**CITY OF SEATTLE
ANALYSIS AND DECISION OF THE DIRECTOR OF THE DEPARTMENT OF
PLANNING AND DEVELOPMENT**

Application Number: 2206195
Applicant: Anders Raman, Architect
Address: 8318 Rainier Avenue South

Master use permit to establish use for the construction of four three-story, 6 unit apartment building with parking for 20 vehicles provided in an existing surface parking lot on site. The existing mixed-use building will remain.

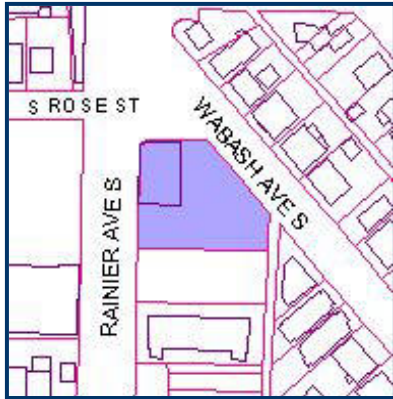
1. Departure from structure depth standards of (SMC 23.45.011.A) – To allow a increase from the maximum depth of 65% lot depth to 76%.

Development Standard	Proposed	Applicant Justification	Board Recommendation
Maximum allowed structure depth is 65% of the lot depth	76% of the lot depth	The angled building creates a residential streetscape	Approve

The Board voted unanimously in favor of the departure.
